HELENA SUBDIVISION

REVIEW COMMENTS

FILE #PP-95-179

TITLE HEADING: Preliminary Plan - Helena
Subdivision

Preferred
Neighborhood
Alternative

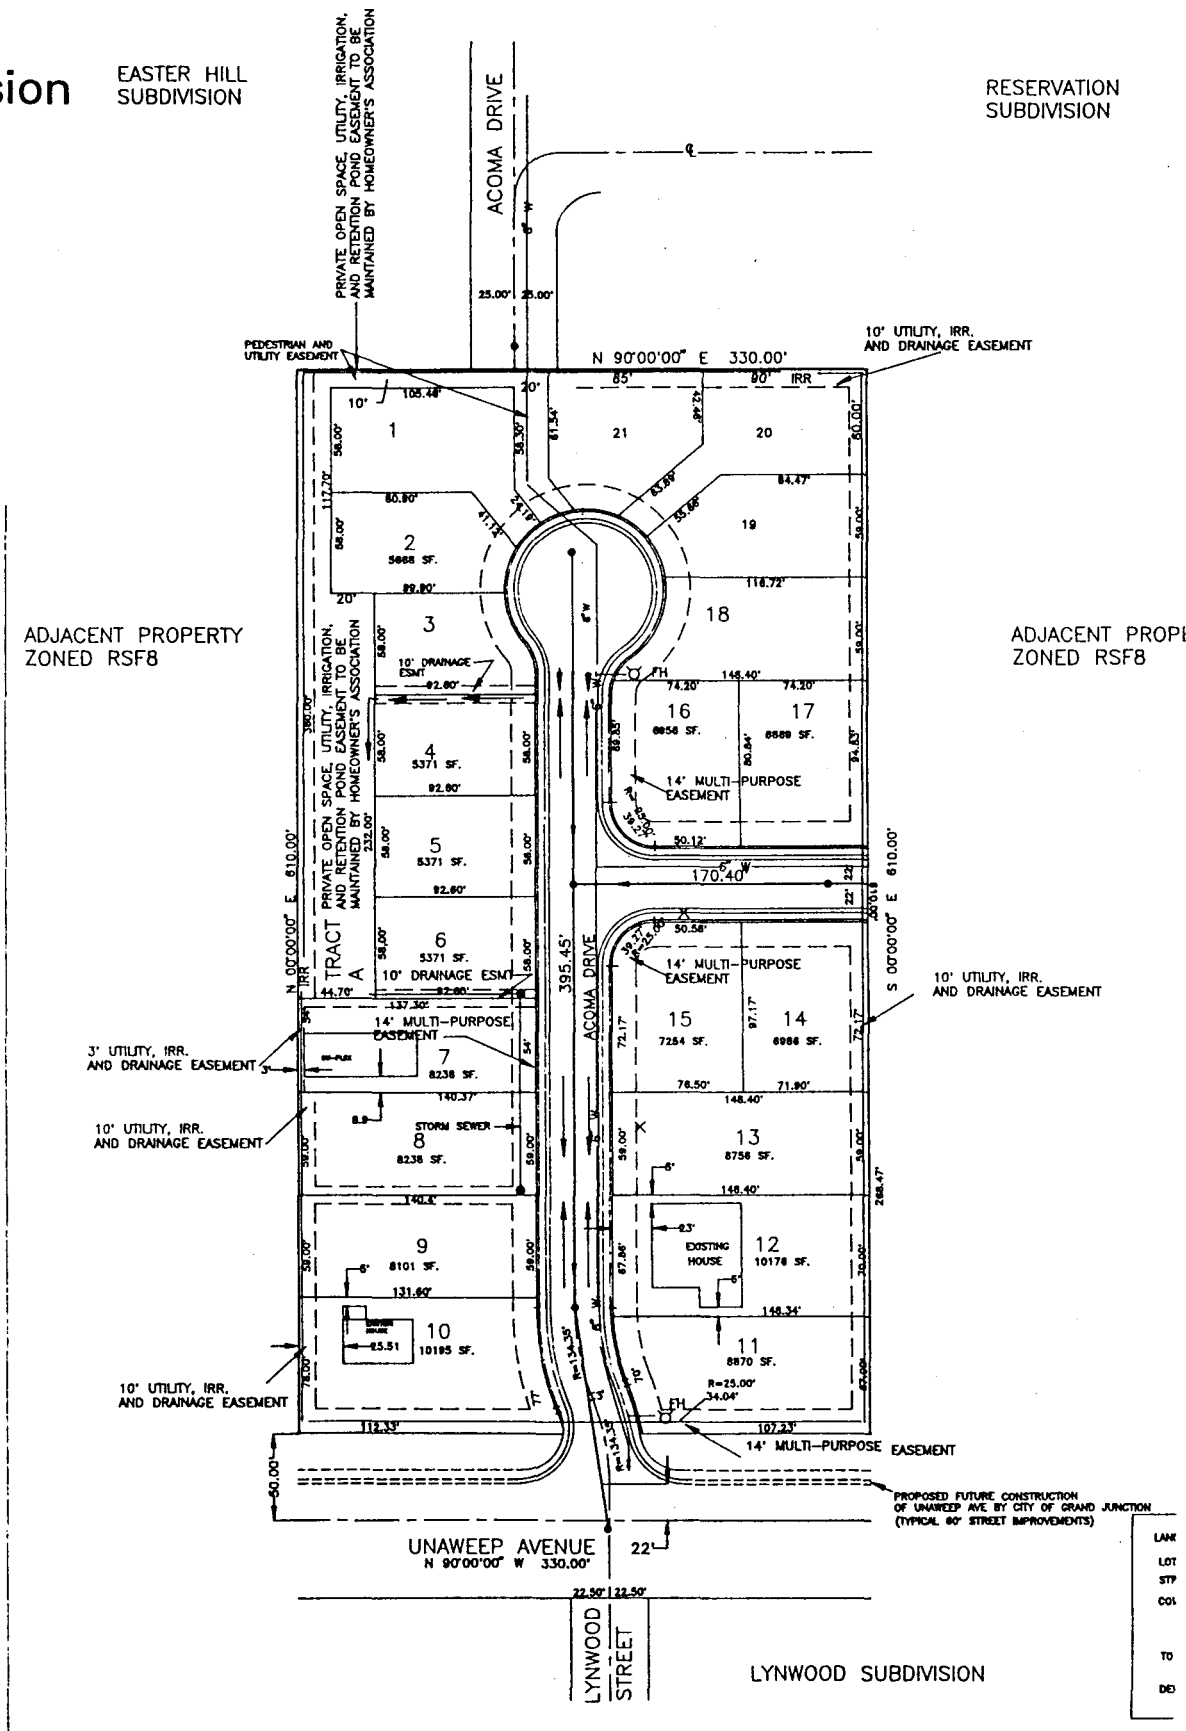
We, the undersigned residents of the RESERVATION SUBDIVISION recommend to the Grand Junction Planning Commission that Acoma Drive in the proposed HELENA SUBDIVISION be a cul-de-sac instead of a through-street.

1. Neighbors in adjoining RESERVATION SUBDIVISION wish to keep traffic flows reduced in their neighborhood for safety of children and pedestrians and for reduced noise.
2. RESERVATION SUBDIVISION currently has 4 access points to UNAWEEP AVE. No new access needed.
3. Real estate values higher on quiet, cul-de-sac lots. A cul-de-sac in HELENA SUB. would make all the lots more valuable (and saleable) with a low traffic street.
4. Lots 1,2,19,20 would be same size as rest of the proposed subdivision with a cul-de-sac. Current proposal has lots 19 & 20 roughly twice the size of the average lot. Long narrow lots are harder to sell because there is so much more for the eventual buyer to maintain.

If the cul-de-sac option is preferred by Council, it is recommended that an additional bicycle/pedestrian path be provided to the Reservation Subdivision to the north per city standards.

Planning Commission
Approved Design

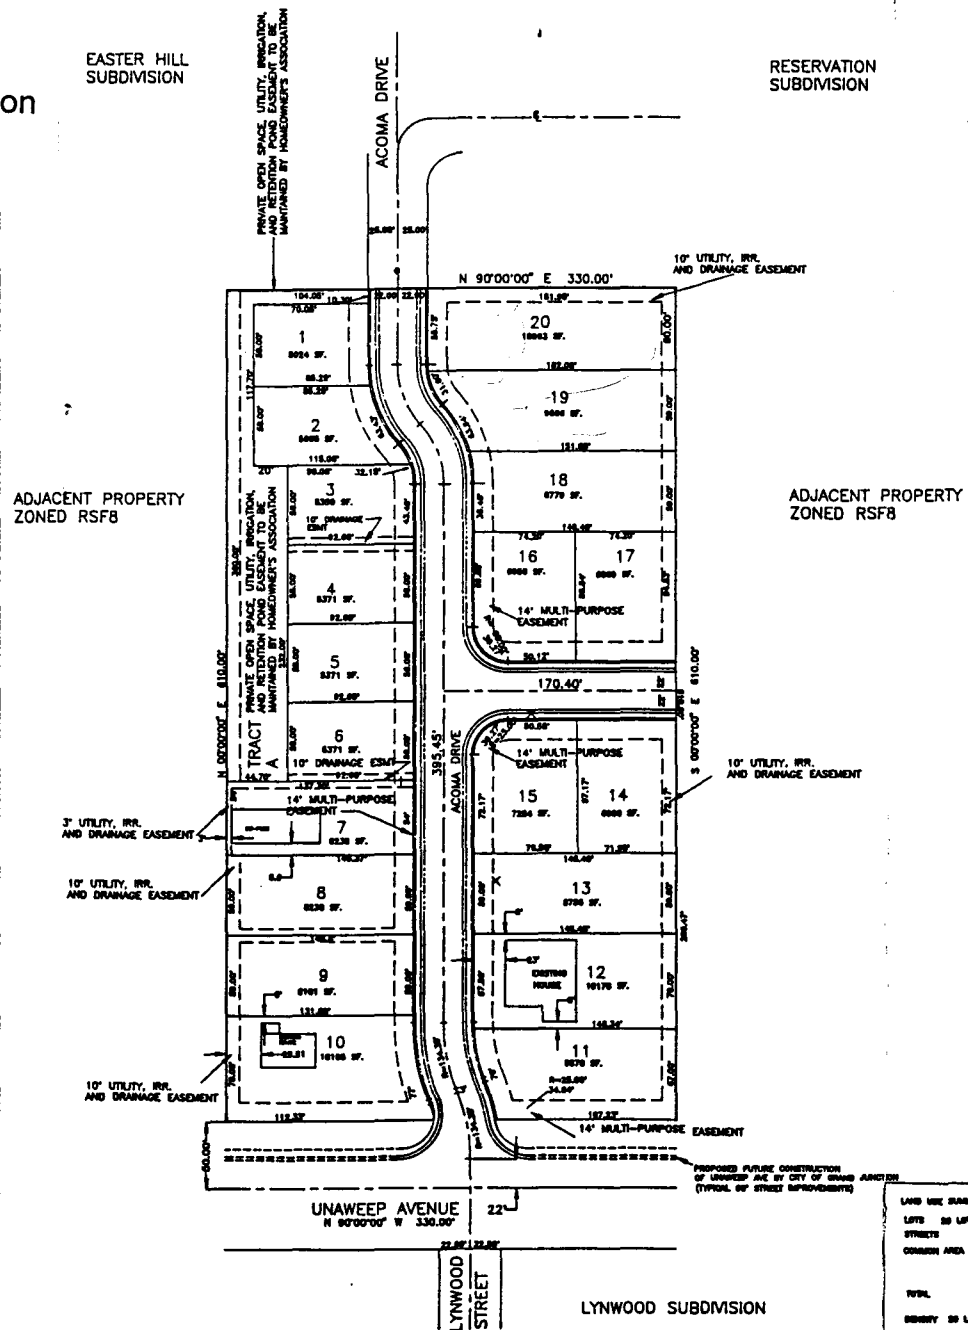
EXECUTIVE SUMMARY: The neighborhood north of the proposed subdivision has appealed Planning Commission's recommendation of approval with Acoma Drive as a through street. This neighborhood requests that the street cul-de-sac at the north end and not be connected to Acoma Drive to the north. There is no disagreement or outstanding issues with the remainder of the subdivision. Staff recommends denial of the appeal because the connection is needed to give the Helena Subdivision an additional access.

STAFF ANALYSIS: The Helena Subdivision is a proposed 20 lot residential subdivision located between UnawEEP Avenue and the Reservation Subdivision to the north. When the Reservation Subdivision was platted, Acoma Drive was left as a stub street to provide access to a future subdivision. The street circulation pattern within the Helena Subdivision is required to connect with this street stub.

At the January 9, 1996 Planning Commission hearing, Paul Nelson of 333 Acoma Court, presented a petition signed by 20 residents, representing 16 property owners, in the Reservation Subdivision. These residents requested that Acoma Drive in the proposed Helena Subdivision be a cul-de-sac instead of a through street. The reasons stated for the cul-de-sac were as follows: to reduce traffic flows in their own neighborhood for safety and to reduce noise; the Reservation Subdivision has plenty of access points already; real estate values are higher on cul-de-sac lots; and a more equitable size for the lots located on the cul-de-sac. Without the cul-de-sac the lots are long and narrow.

STAFF RECOMMENDATION: Staff recommends that the Planning Commission's decision be upheld and that the Helena Subdivision be approved with Acoma Drive as a through street to the Reservation Subdivision, with the following condition.

1. That a minimum 10 foot wide pedestrian access easement for the vacant lot to the west be dedicated for public use and shall be shown and improved on the final plat.
